# ADDENDUM NO. 1 BID OPPORTUNITY NO. 15-2004

CITY OF WINNIPEG OFFICE ADDITION AND RENOVATION  
1155 PACIFIC AVENUE, WINNIPEG, MANITOBA

ISSUED: June 18, 2004  
BY: Coleen Groening /clg  
TELEPHONE NO. (204) 986-2491

| File No.<br>02-018-01 | Date<br>MAY 2004   | Detail Sheet<br>MD-30R1 |

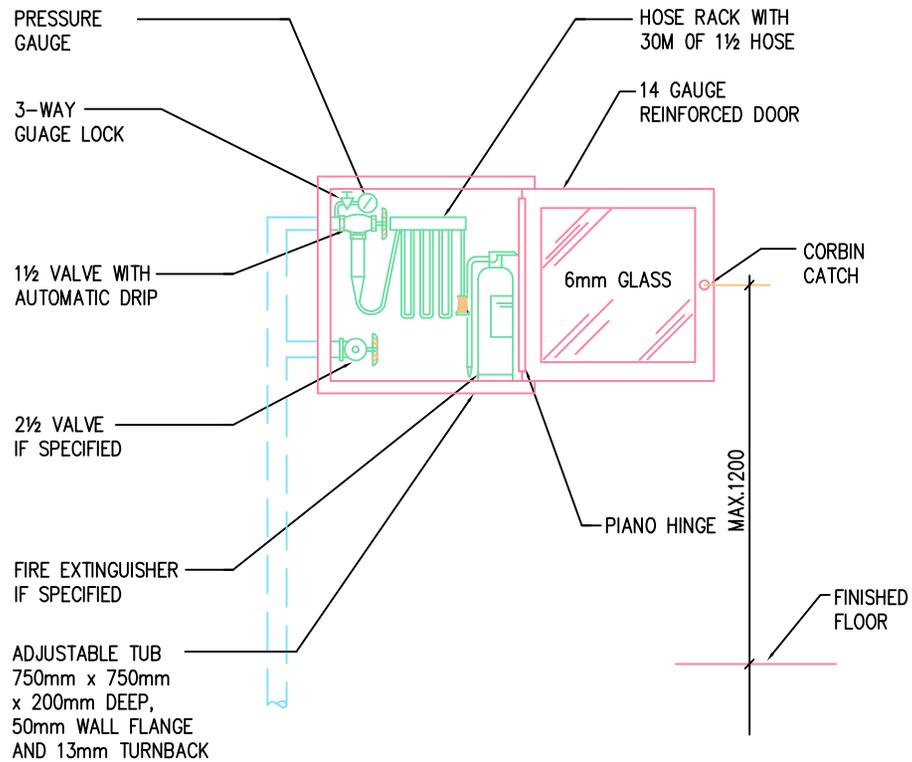
- Replace MD-29 with MD-29R1 (attached).
- Replace MD-30 with MD-30R1 (attached).
- Replace MD-34 with MD-34R1 (attached).
